Ibex Lighting Project No: 9514

**PROPOSED SUNFIELD MASTERPLANNED COMMUNITY
ARDMORE AIRPORT SAFEGUARDING – LIGHTING and GLARE**

3. Review Proposed Sunfield Development – Ardmore Airport Safeguarding Section 5.5 Lighting and Glare

The Lambert & Rehbein Report Figure B22156/07 Rev 3 in Appendix A sets out these control zones relative to the Ardmore Airport runway and identifies that the proposed Sunfield Development impacts all four zones. The plan has been extracted from the report and inserted below for ease of reference.

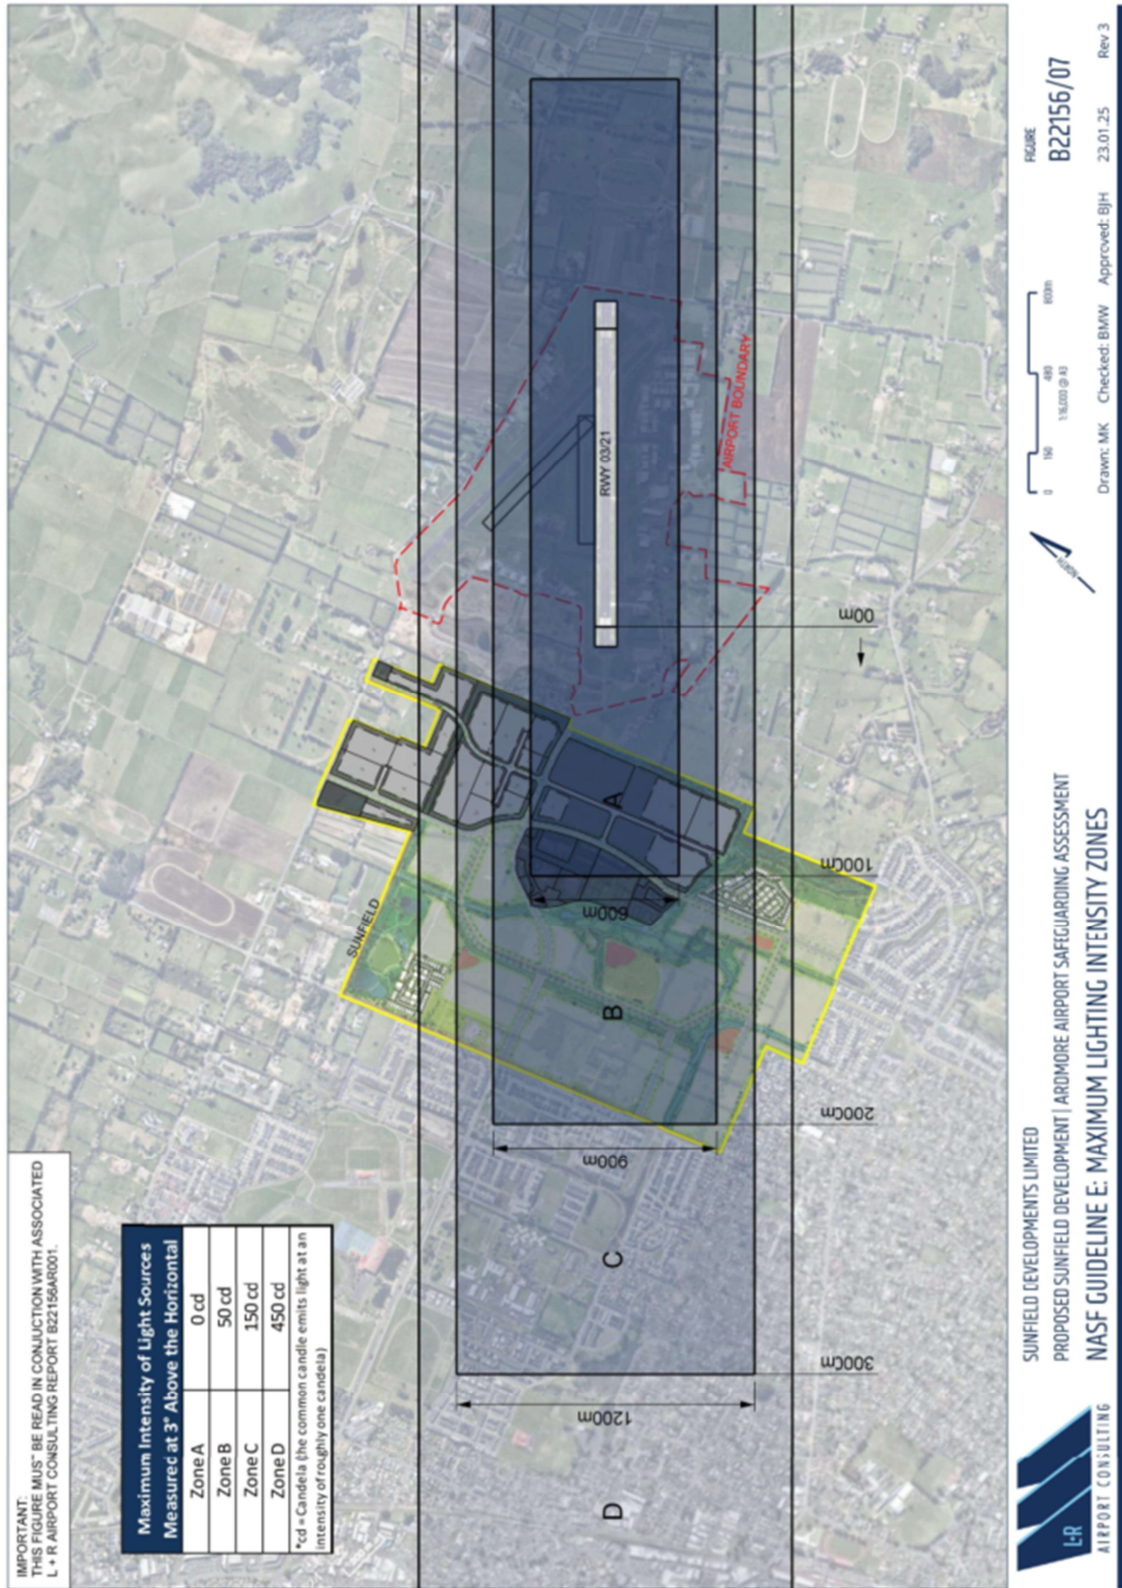
NASF Guideline E defines four light control areas namely A, B, C and D, with increasing light intensity outputs the further the control area is away from the centre point of the runway.

- Zone A – 0 cd
- Zone B – 50 cd
- Zone C – 150 cd
- Zone D – 450 cd
